Combined Design Review

Date: June 25, 2020 – DRB Meeting Date

**CITY OF OLYMPIA**  
**MULTI-FAMILY RESIDENTIAL**  
**Chapter 18.170**

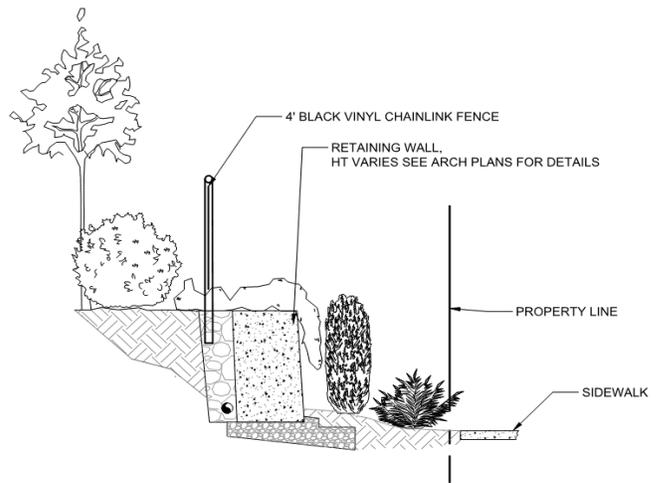
**STAFF RESPONSE:** The physical characteristics of the two retaining walls that wrap around the development site are:

- Ketner Place Frontage: approximately 430 linear feet, ranging in height from approximately 1 to 9 feet in height at the tallest point.
- Alta Street Frontage: approximately 500 feet in length, ranging from 1-6 feet in height at the tallest point.

A 4-foot tall chain link fence will sit atop the walls and landscaping will be installed as shown on Sheets L1.0-L1.6. Gates or openings in the retaining walls that would allow connections to and from the site to adjacent streets, to the community park north of the site, and to the transit stop south of the site adjacent to Capital Mall Drive, are missing. As currently designed, some residents will need to walk over 1,000 feet from the south end of the development to the driveway access north on 6<sup>th</sup> Avenue, then south again to the catch a bus on Capital Mall Drive. The project should include openings through the walls, either to each frontage, or every 300 feet that allows direct accessible connection to the street frontage, sidewalks, and transit stop.

There are columns along the walls at 30-foot intervals, depicted in the architectural plan set and landscape plan (Attachments 3 and 4) but there are no design details of the columns or walls themselves such as materials, colors, or finish details.

- Provide openings in the retaining walls that allow direct accessible connections to the street frontage, sidewalks, and transit stop. See also OMC 18.170.020.
- Provide designs of the retaining walls and columns including materials, colors, and finish details. OMC 18.170.050 and OMC 18.170.140.

**ALTA ST. RETAINING WALL PLANTINGS**

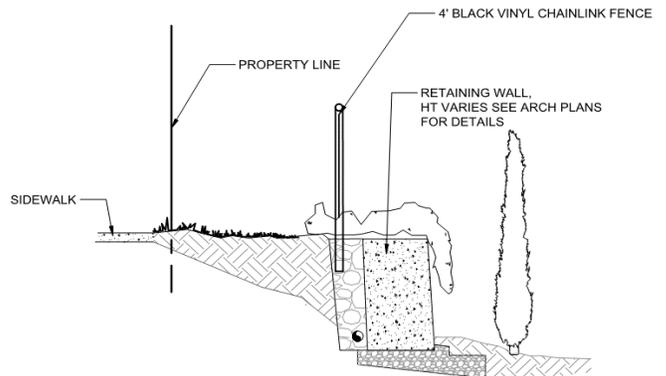
**STAFF RESPONSE:** Native plants, drought tolerant plants, or climate adaptable Pacific Northwest plants are necessary and required both in this design code and in the City’s Landscaping and Screening Code, OMC 18.36. The plant schedule is shown on Sheet L1.0 but the percentage or quantity of native plantings is not clear. The landscape plan should also be comprised of hanging or draping plants, vertical climbing plants or other plants that establish well along walls.

- Include in the planting schedule hanging or draping plants, vertical climbing plants or other plants that establish well along walls.

BUILDING TYPE A - FRONT ELEVATION

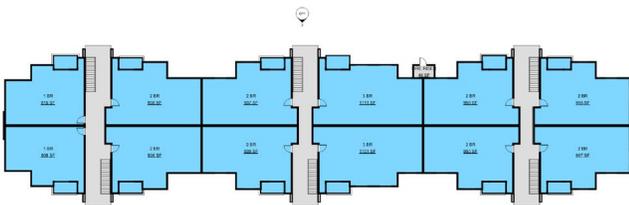
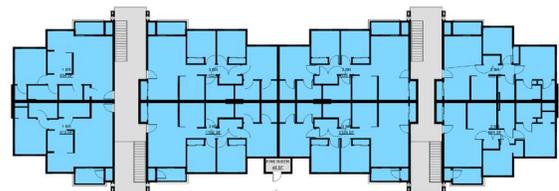
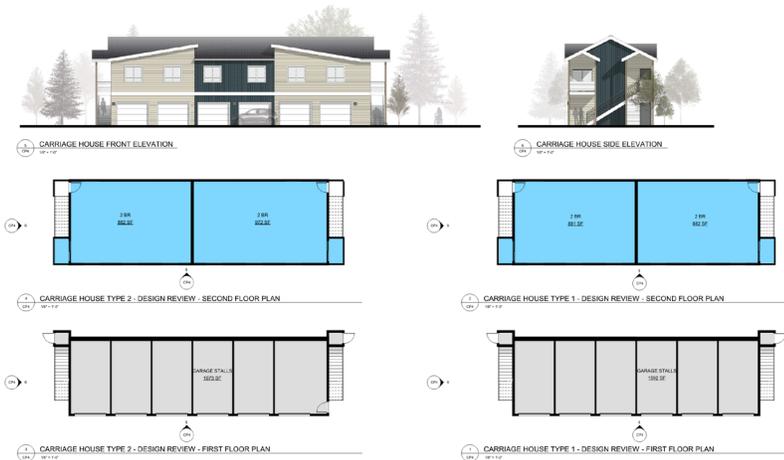
However, the carriage-garage units are two story rectangular buildings with flat facades – inconsistent with the other buildings such as the clubhouse and apartment buildings. All facades should be attractive and well-proportioned. The carriage-garages should exhibit the same extent of secondary architectural features that exist in the apartments and clubhouse.

- Add depth to the facades of the carriage garage buildings. For consistency and continuity in design among the buildings, incorporate elements of design used on the larger buildings.
